Public Works Standard Drawings Subcommittee Meeting

Monday, April 13, 2020 WebEx

Division 2000: Pavement Systems

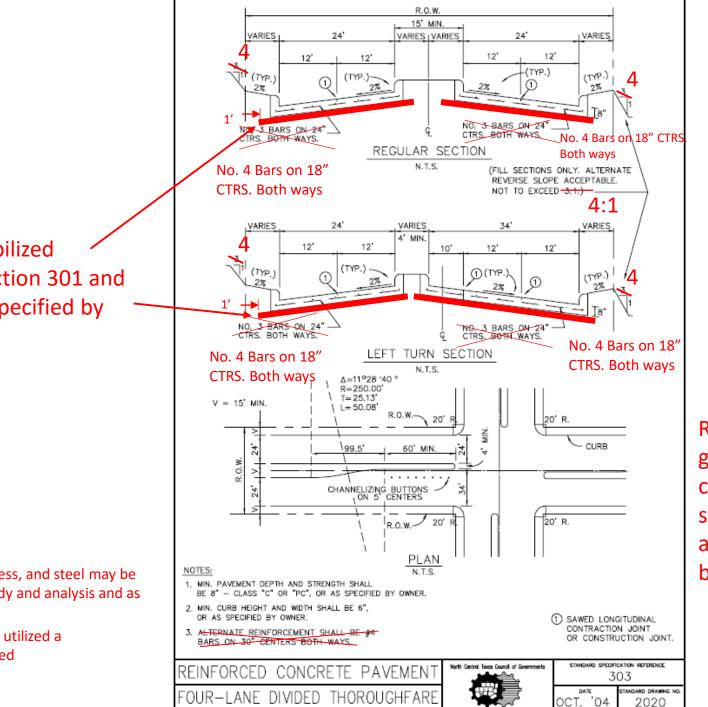
Replace Plan with a more general layout to include crosswalks, ADA ramps, striping, and possibly additional lane width for bicycle lanes per TxDOT 8" minimum stabilized subgrade per section 301 and as approved or specified by – owner

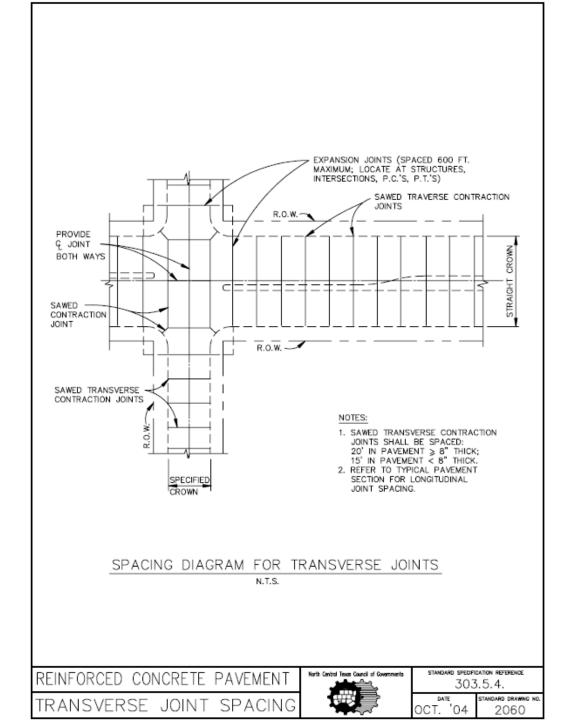
Replace Plan with a more general layout to include crosswalks, ADA ramps, striping, and possibly additional lane width for bicycle lanes per TxDOT

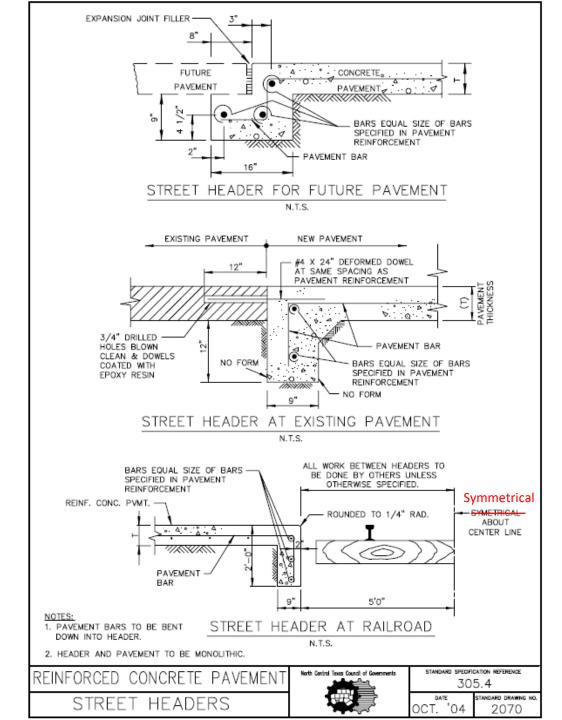
*cleanup lines through median

2125B

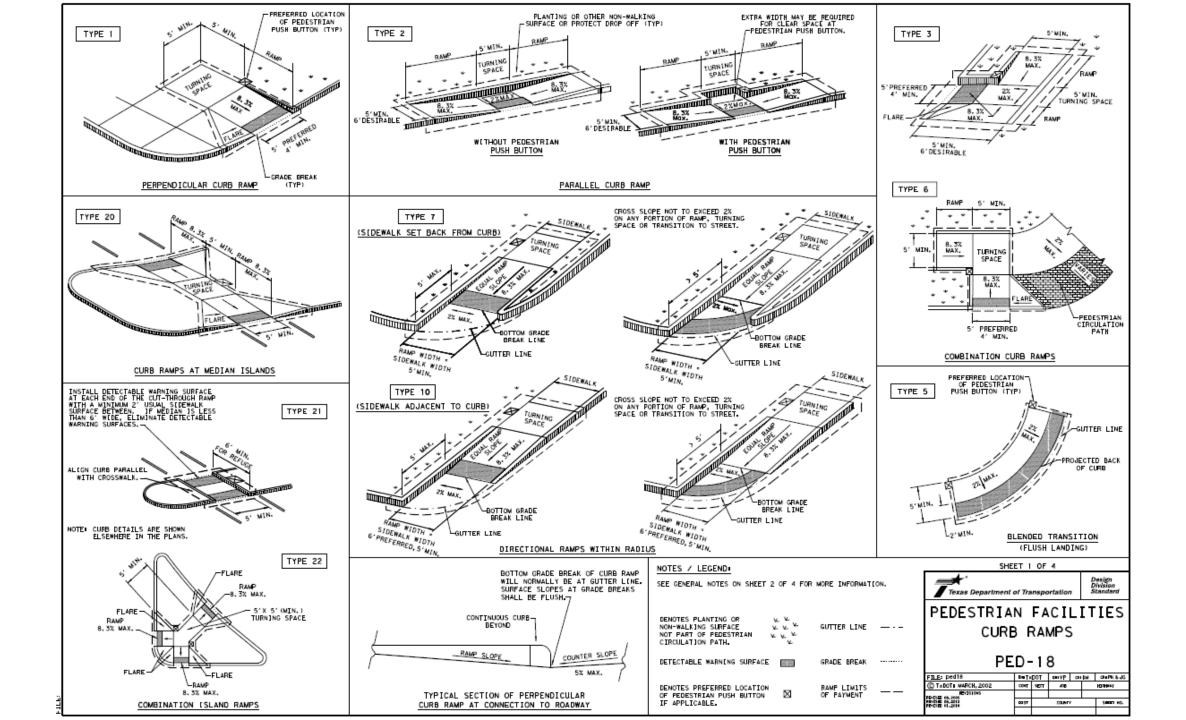
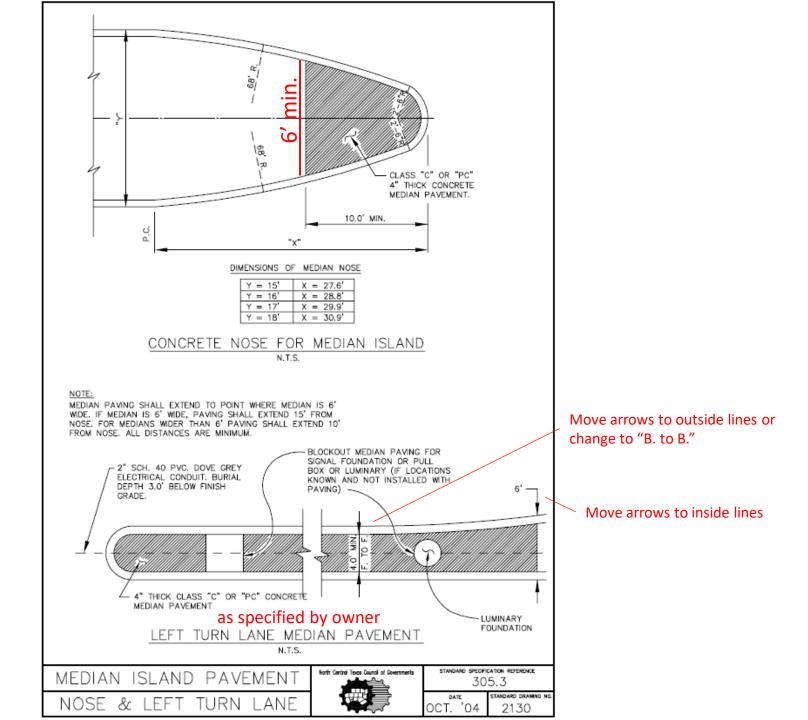
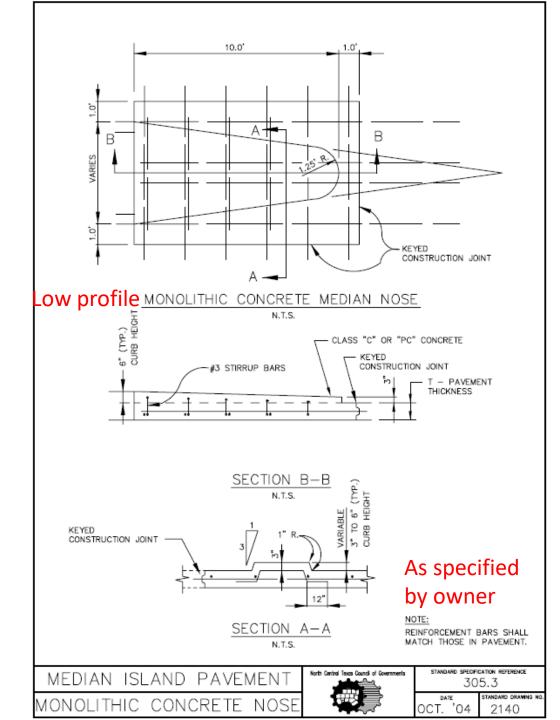
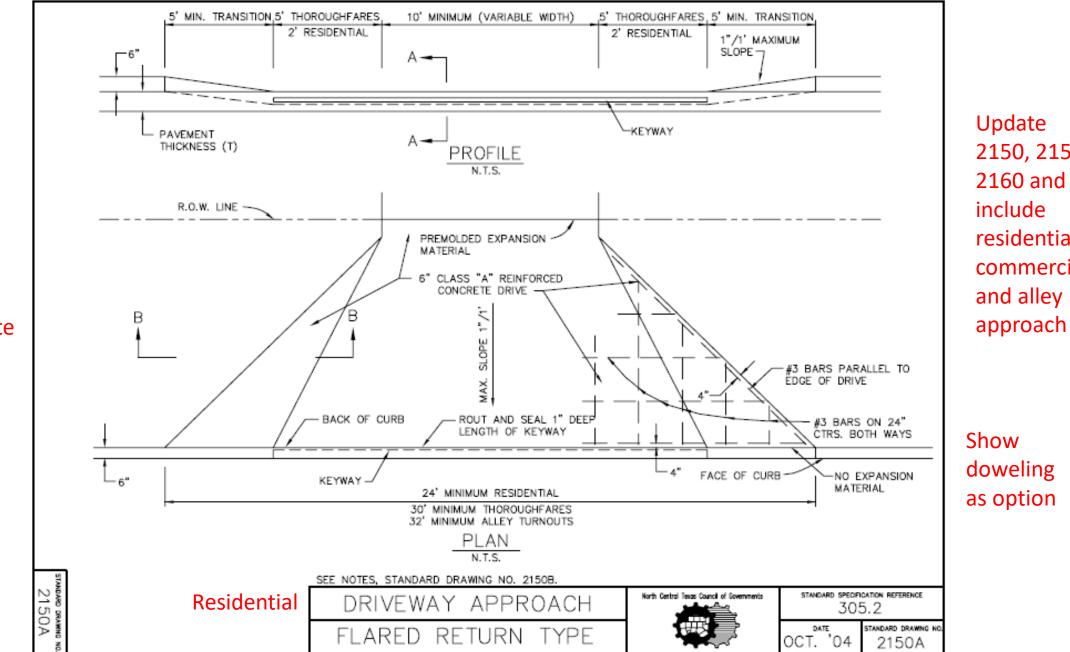
Update and remove 2125A or update to reference other detail

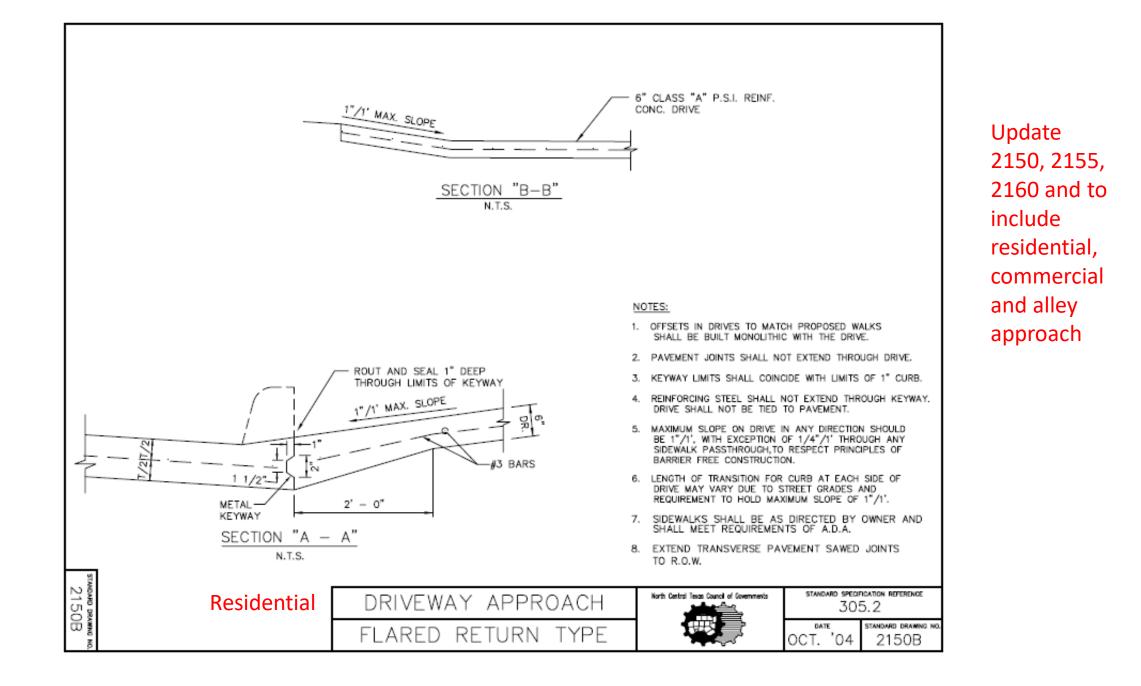
Eliminate keyway joint

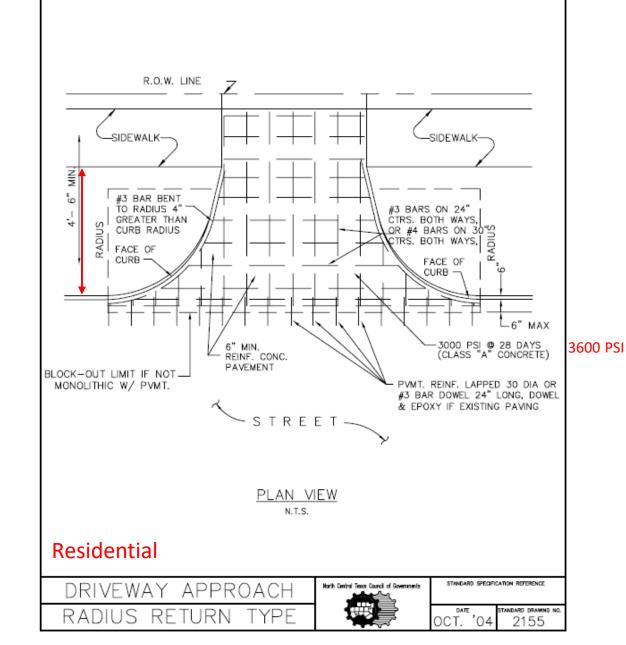
2150, 2155, 2160 and to residential, commercial

Add cross section view like 2150A

Driveway

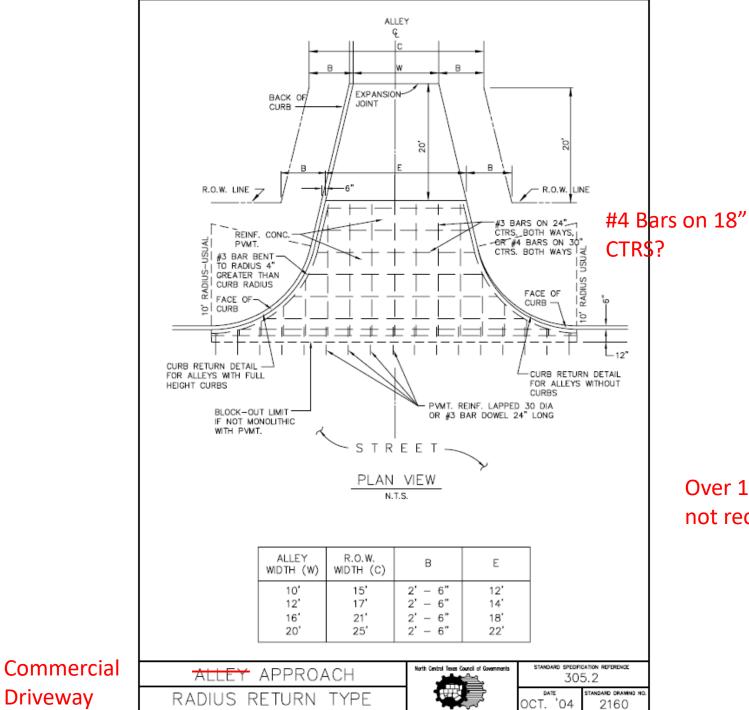
Update 2150, 2155, 2160 and to include residential, commercial and alley approach

Update 2150, 2155, 2160 and to include residential, commercial and alley approach

Over 12% grade break is not recommended?
